SERVICE LETTER

No. 362B

Piper Aircraft Corporation

Modification of Windshield Top Attachment

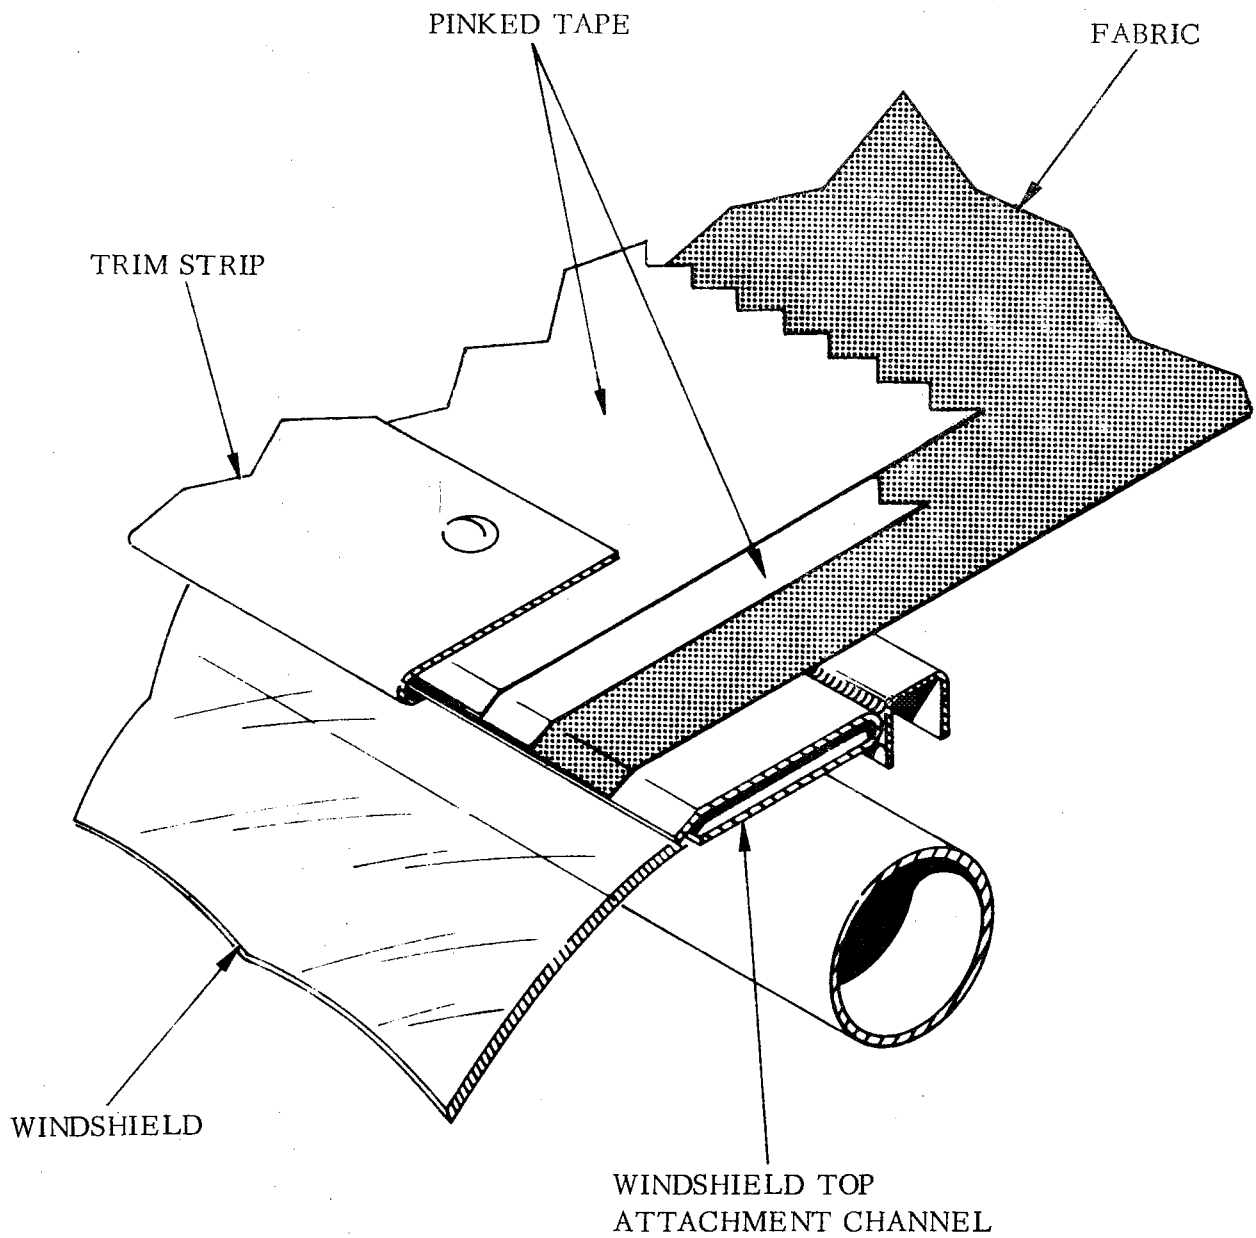
To provide material and instructions to reinforce the area where the fabric attaches to the fuselage under the windshield top and/or directly over the rear edge of the windshield top attachment channel on the above referenced aircraft. The attached sketch illustrates this area.

Contained in Fuselage Fabric Trim Strip Installation Kits, Piper part numbers 754 404 and 760 799 (reference Material Required, below).

1. Applies to PA-15, PA-16, PA-17 and PA-20 aircraft listed above, and PA-22 aircraft serial numbers 22-1 to 22-7630 incl.: One (1) each per aircraft Fuselage Fabric Trim Strip Installation Kit, Piper part number 754 404, at \$2. . . A suggested unit retail price.
2. Applies to PA-12 and PA-14 aircraft listed above: One (1) each per aircraft Fuselage Fabric Trim Strip Installation Kit, Piper part number 760 799, at \$4.58C suggested unit retail price.
